Findings of Fact | Site Plan Review

City of Portsmouth Planning Board

Property Address: 635 Sagamore Avenue

Application #: LU-22-209

DRAWING No. **C3**
 SHEET 6 OF 21
 JBE PROJECT NO. 18134.1

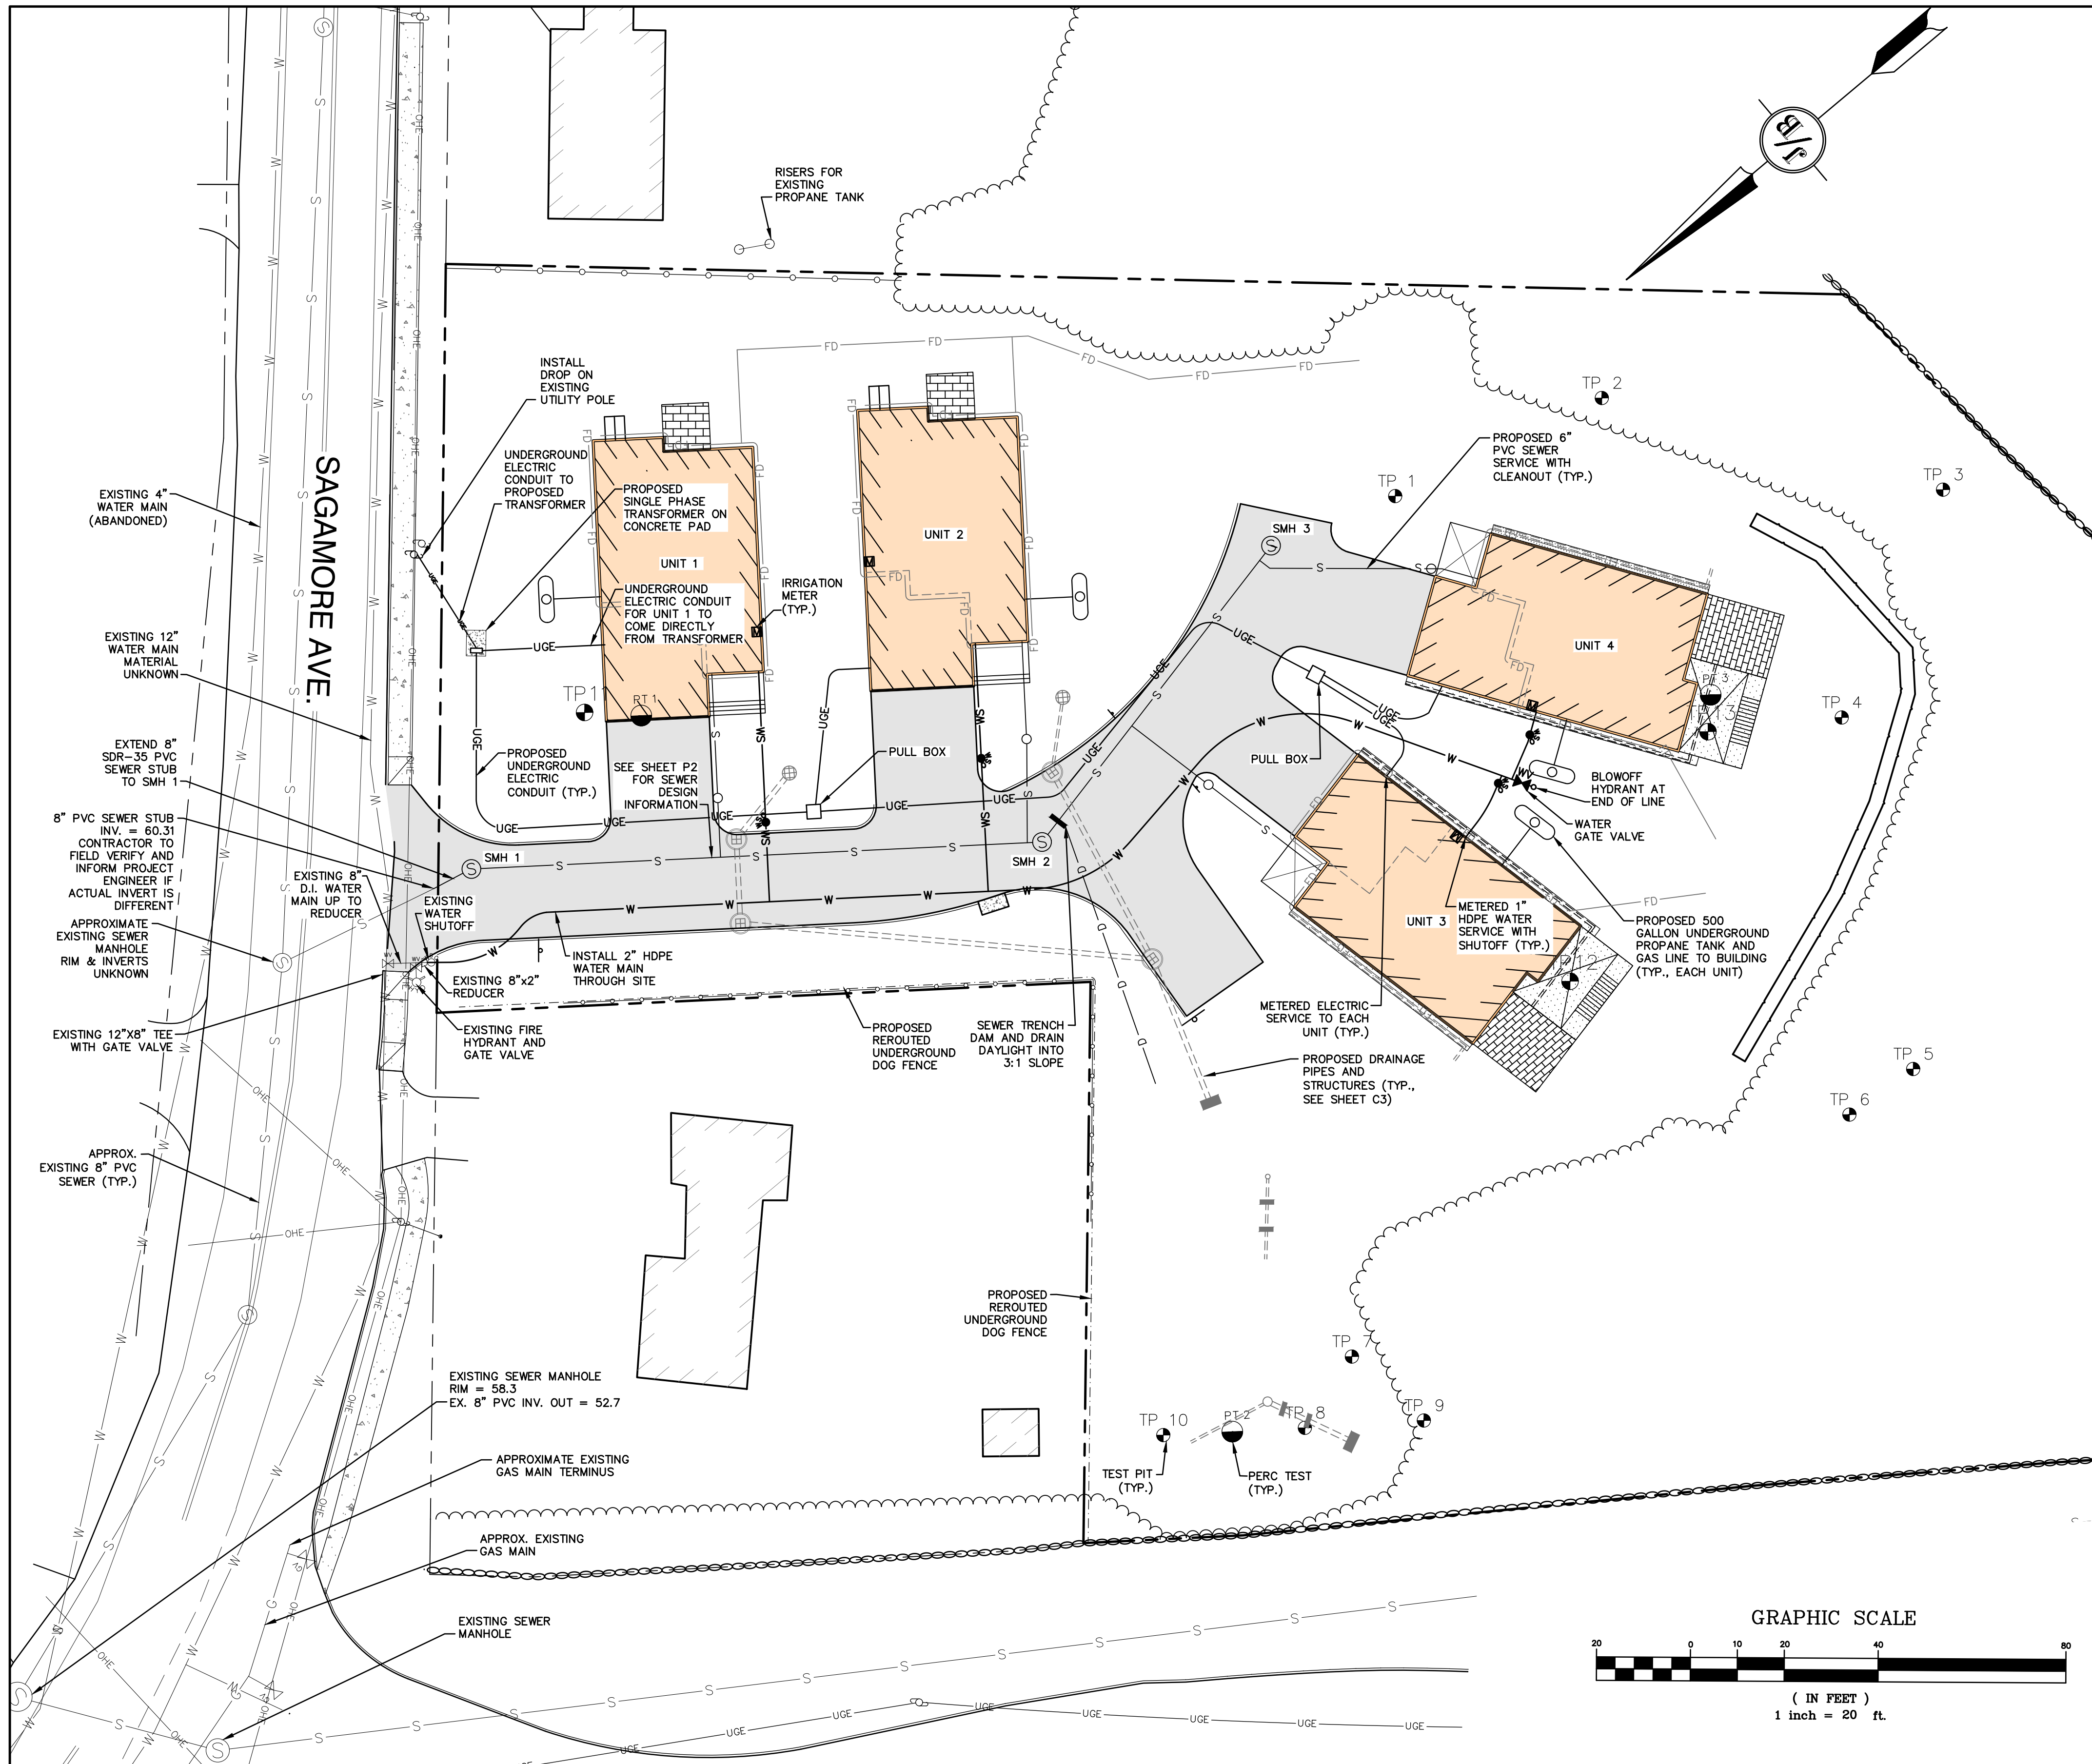
2. Key elevations should be added to the stone infiltration basins under the decks for Units 3 and 4. Additionally, the design computations include an assumption that there will be no ledge to elevation 62.33 for building 3 and elevation 61.0 for building 4. Notes should be added to the plan requiring inspection of the subgrade to ensure that the design criteria are met.

RESPONSE: Specifications for the top and bottom of stone elevations relative to existing grade have been added the labels for the stone infiltration beds on Sheet C3. Additionally, notes have been added to the "Infiltration Stone Underneath Deck" detail on Sheet D5 directing the contractor to remove ledge to at least 2' below existing grade in the footprint of these practices if encountered, and to verify that existing subgrade has not been excessively compacted prior to placement of stone.

DRAWING No.	H1
SHEET 12 OF 21	JBE PROJECT NO. 18134.1

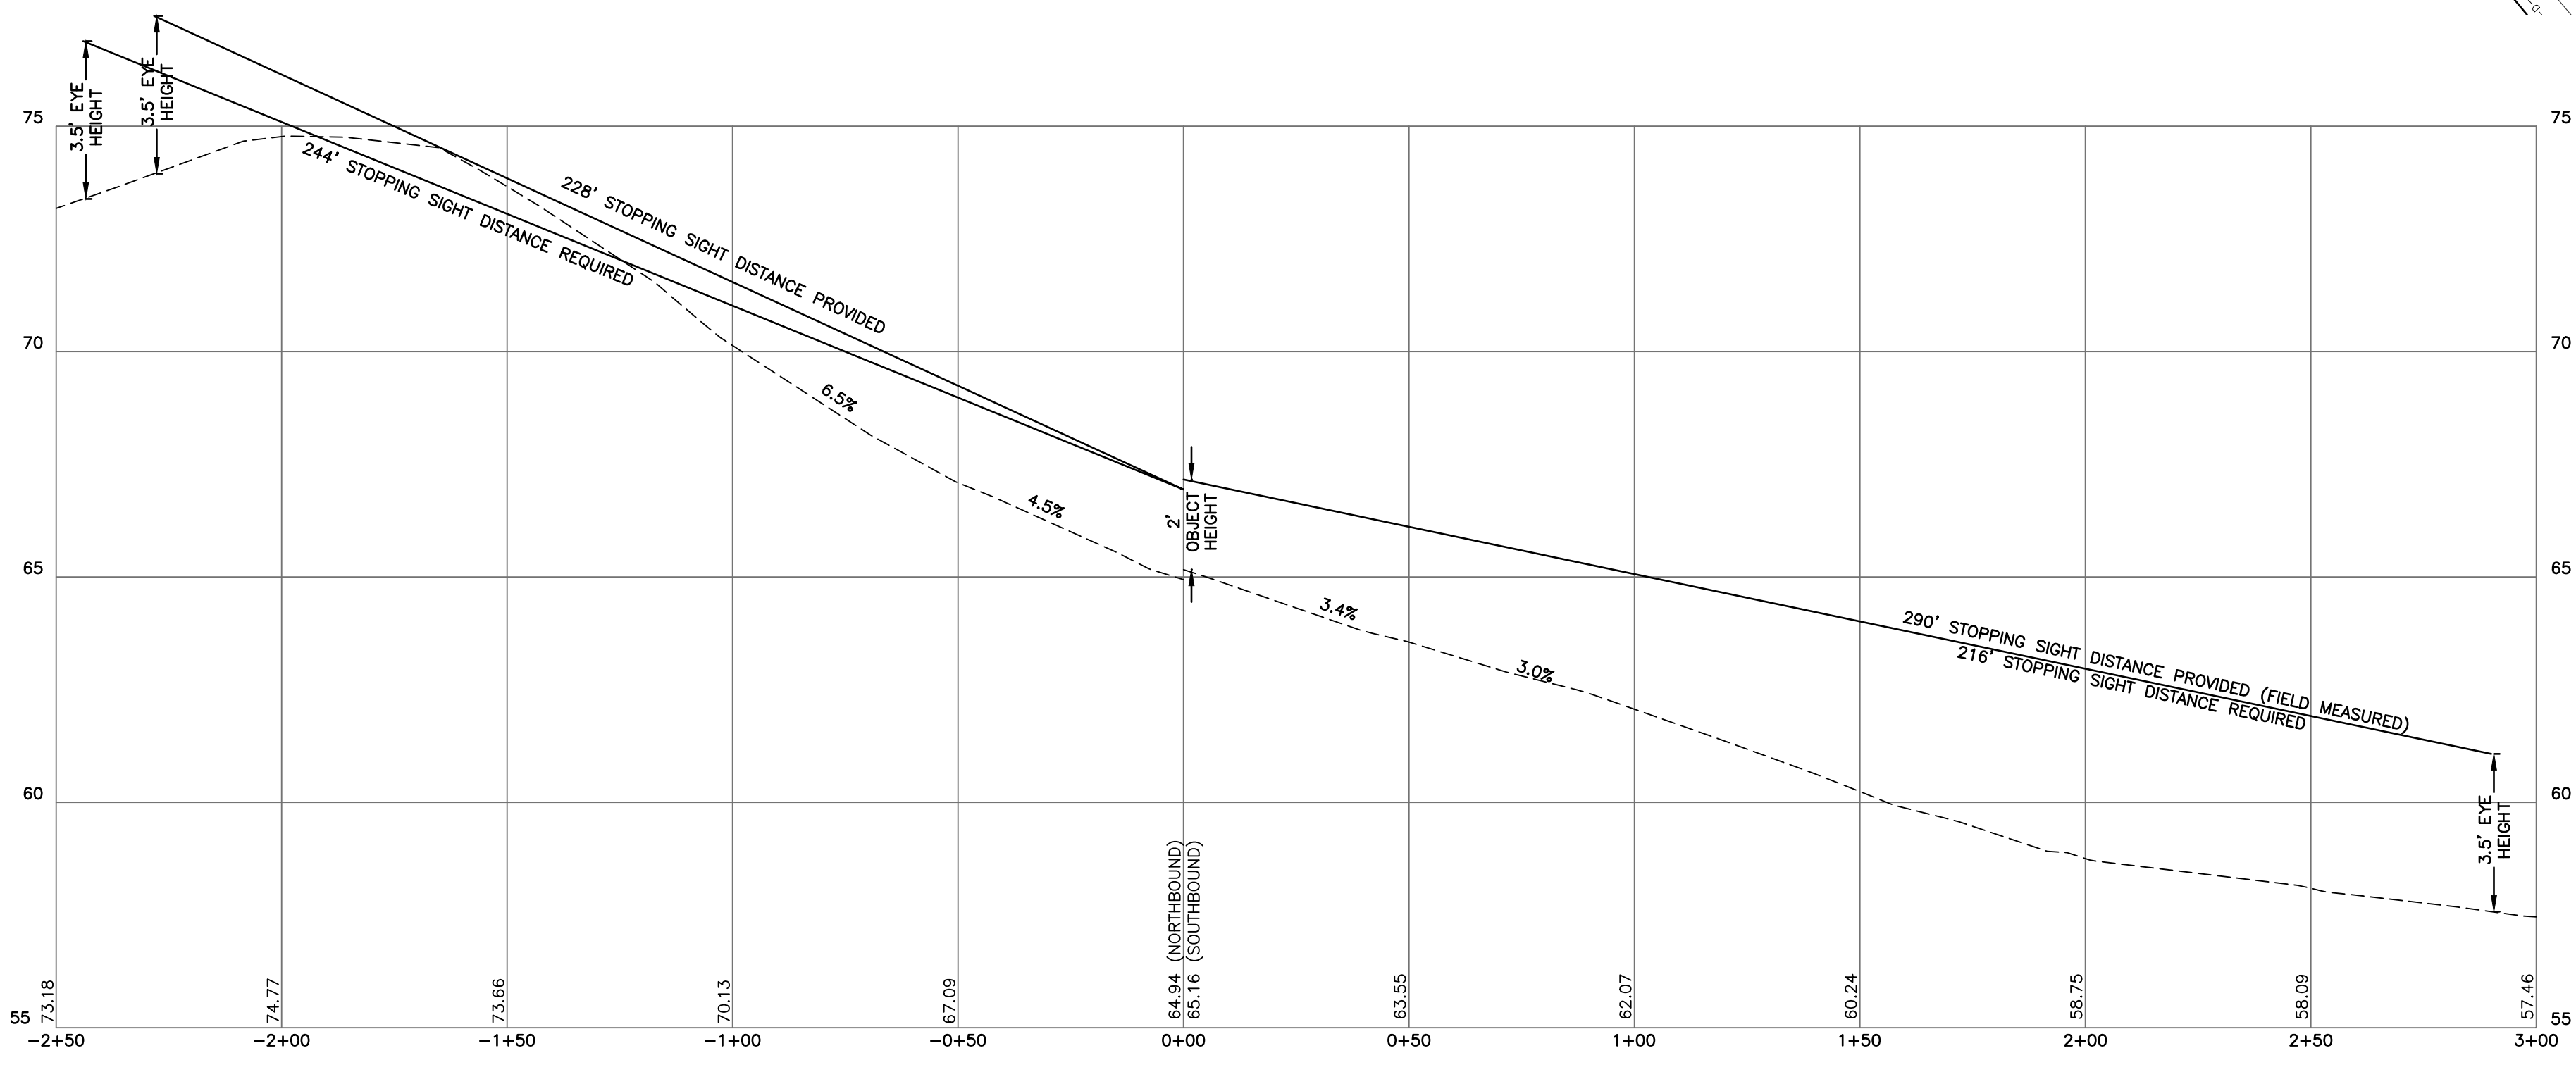
Looking at the plans, it appears that the sight line was plotted along the red dashed line. However, this line would represent the intersection sight line and not the stopping sight line. The 2-foot object height for stopping sight distance needs to be at a point in the travel lane, not at a point 14.5 feet from the edge of the travel lane. Stopping sight distance is for approaching vehicles to be able to see and react to a vehicle stopped in Sagamore Ave waiting to turn left into the site driveway. I don't know how much of a difference, if any, the location of the 2-foot object will have on the sight lines, but it needs to be shown and the report updated to reflect the proper location.

Joe
Thank you for the plans and the update. Looking quickly at the profile plans, you have provided plans for both Intersection Sight Distance (ISD) on Sheet H1 and Stopping Sight Distance (SSD) on Sheet H2. ISD is for vehicles turning out of the driveway. SSD is for vehicles approaching the driveway on Sagamore Ave. The ISD appears to be plotted correctly. However, in the case of SSD, the 3.5-foot driver height should be a 2-foot object height. Revising the plans

SAND ABSORPTION AREA

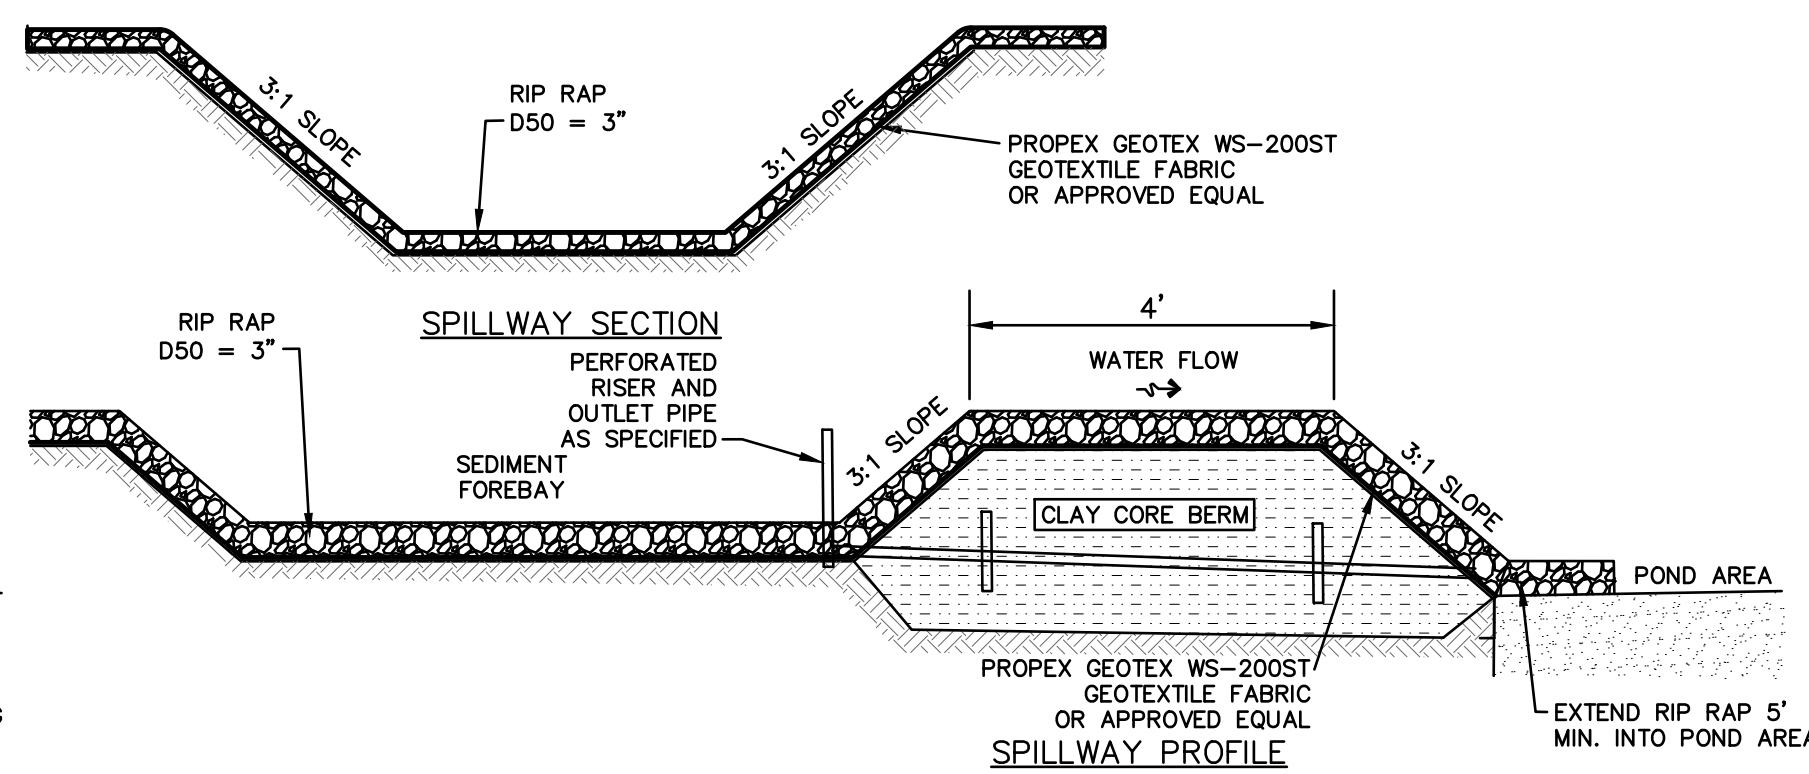
3. The Designer is proposing to provide “sand absorption areas” for the gravity foundation drainage discharge. The absorption area for building units 1 and 2 is approximately 30- feet from the nearest test pit. Altus recommends that notes be added to the plans requiring confirmation that there is adequate separation to ledge.

4. The sitework details for both the sand absorption area and the infiltration stone underneath deck specify native material is placed beneath and adjacent to the systems. It is Altus’ opinion that the Designer should provide gradation and compaction requirements for the placement of the fill. The detail should include a minimum depth of native material below the treatment area as well as down gradient.

RESPONSE: Note #4 has been added to the sand absorption area detail on Sheet D4 specifying that a test pit shall be performed prior to construction of these practices in order to confirm adequate separation to ledge, and that ledge shall be removed to at least 12” below the bottom of the practice if encountered.

RESPONSE: We revised the sand absorption area detail to specify that the sand, per the specified gradation, shall be placed from existing grade to finished grade. The material below that will be uncompacted in-situ soil. Fill material on the downgradient slopes will be suitable backfill from the subject parcel. The same sand gradation from the sand absorption area detail has been added to the detail for the stone infiltration beds underneath unit decks and the detail has been revised to state that this sand material shall be placed from existing grade to the bottom of stone on these features.
